> Customer Product Information (CPI)

Product group:	SEMIPACK	Rev.: 1
No.:	PN20-096	02 Nov 2020
Minor change of DBC layout for SEMIPACK 2 modules (time schedule updated)

Subject of change: DBC layout

Current DBC layout (as example SKKT 162)

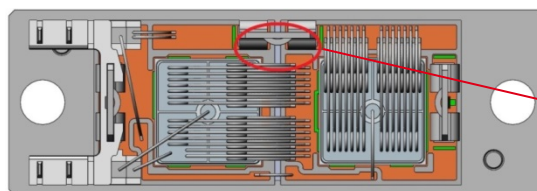
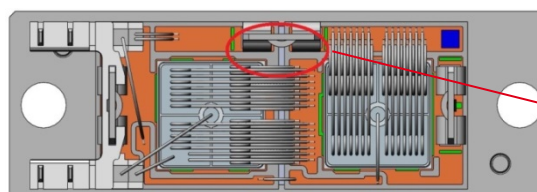
Description of change: Changes in the marked area to achieve constant larger distance between the terminal feet and the adjacent copper area. The change does not affect the current path and has no impact on electrical and mechanical properties of the modules.
